An
Bord
Pleanála

Planning Appeal Online Observation

Case Number / Description
314485

Dublin Airport, Co. Dublin

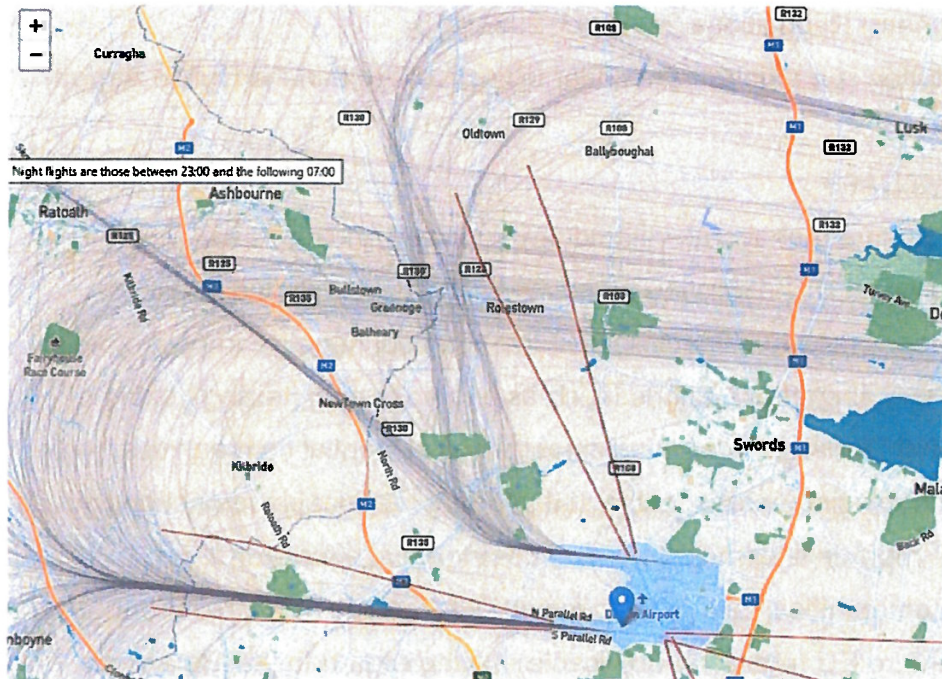
- Flying divergent flight paths on the North Runway for Westerly operations contravening the EIS of 2007
- Divergent flight paths currently in operation do not align with EIAR for this current planning application that is under appeal

- 30-degree divergence was not proposed in the 2016 consultation
- Condition 3 of planning does not allow for dual runway departures under Option 7b
- Flight paths used in Insulation Scheme approved by Fingal County Council in 2016, based on 2007 planning permission, show straight out operations

- Departures on North Runway on August 25-27th and all dates of westerly departures since opening are showing divergent routes contravening the planning permission from 2007
